Planning Application No. A/YL-NSW/323

Responses to department comments for the application

Proposed Temporary Shop and Services and Vehicle Repair Workshop for a Period of 3 Years

Lot 3614 RP in D.D. 104

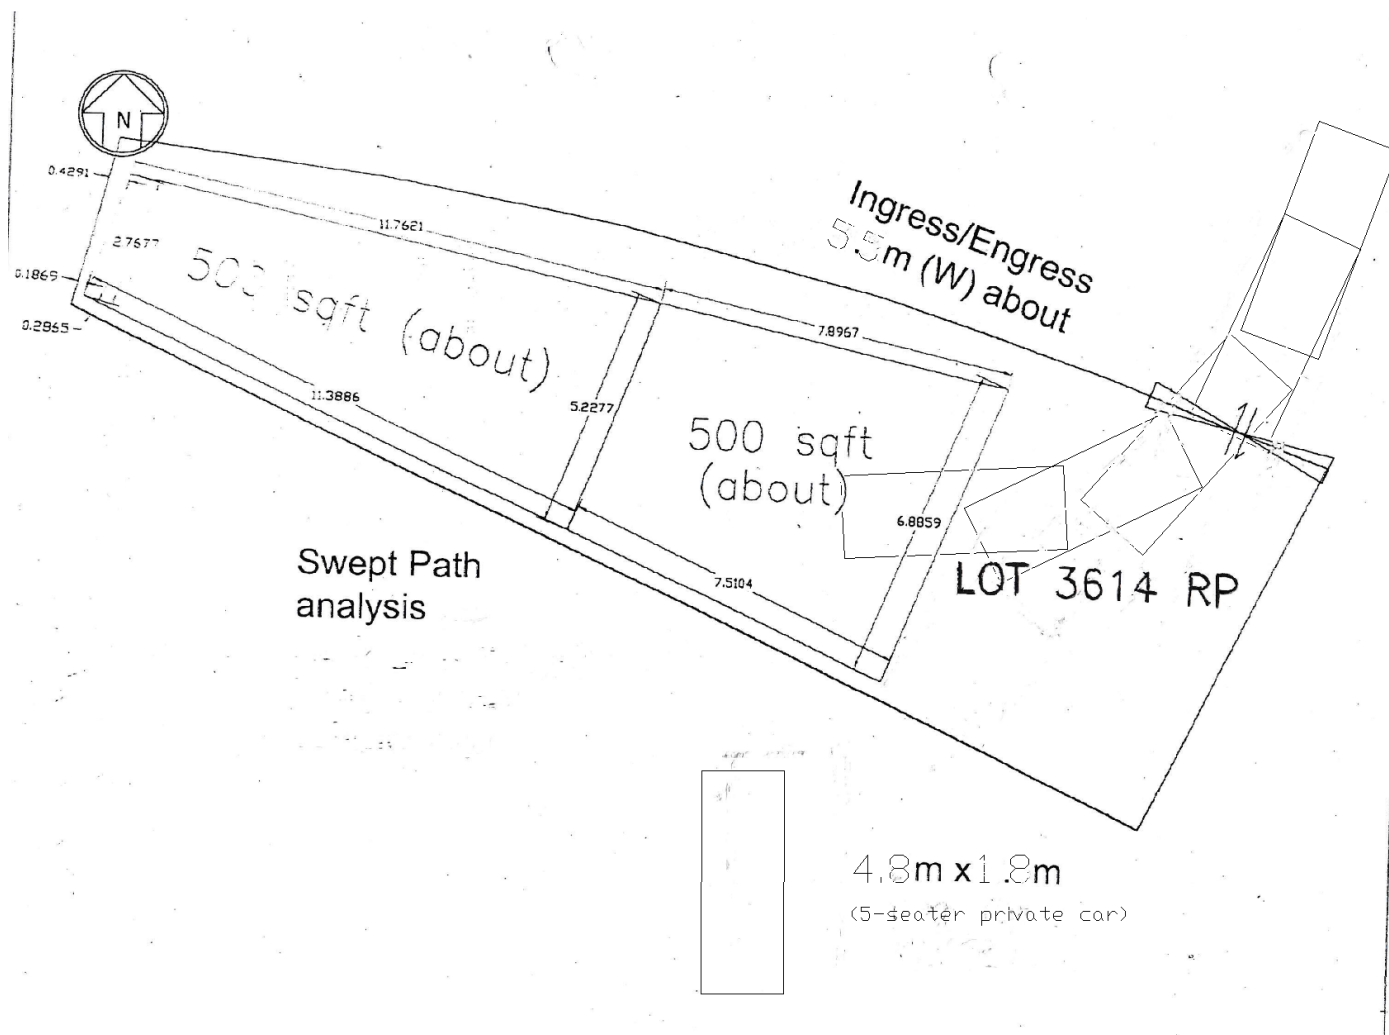
2. It is noted that the width of the ingress/egress is proposed to be 5.5m width. The applicant should indicate the exact location and clear width(s) of the vehicular ingress/egress on a plan with scale and demonstrate sufficient space for manoeuvring of the types of vehicles allowed entering, leaving and within the subject site by swept path analysis.

Our response: Please refer to the diagram below.
